**Agreement concerning the International Carriage of  
Dangerous Goods by Road (ADR)**

**Draft amendments to annexes A and B of ADR**

**Note by the secretariat**

“6.8.3.2.9.6 Safety valve mark

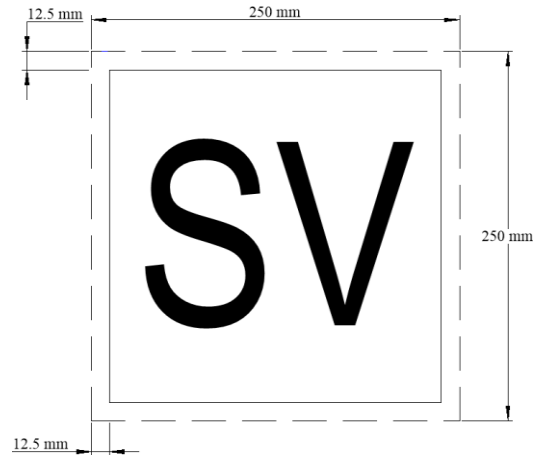
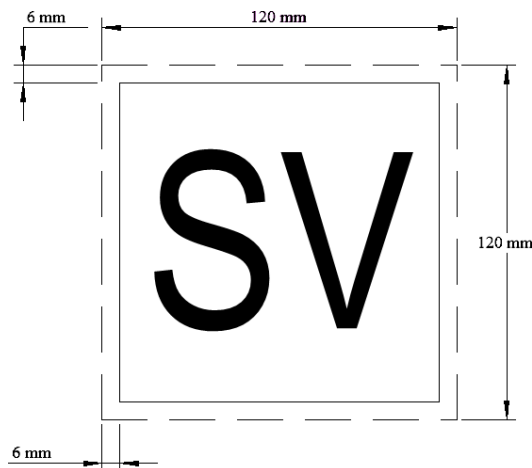
6.8.3.2.9 Insert the following new 6.8.3.2.9.6:

6.8.3.2.9.6.1 Tanks fitted with safety valves in accordance with 6.8.3.2.9.1 to 6.8.3.2.9.5 shall display the mark as set out in 6.8.3.2.9.6.3 to 6.8.3.2.9.6.6.

12.5 mm from the outside of that line to the outside edge of the mark. The letters "SV" shall be black, a minimum of 120 mm high and have a minimum stroke thickness of 12 mm.

6.8.3.2.9.6.4 For demountable tanks | For tank-containers

with a capacity of not more than 3 000 litres the mark may be reduced in size to not less than 120 mm × 120 mm. The line inside the edge shall be black, parallel and approximately 6 mm from the outside of that line to the outside edge of the mark. The letters "SV" shall be black, a minimum of 60 mm high and have a minimum stroke thickness of 6 mm.
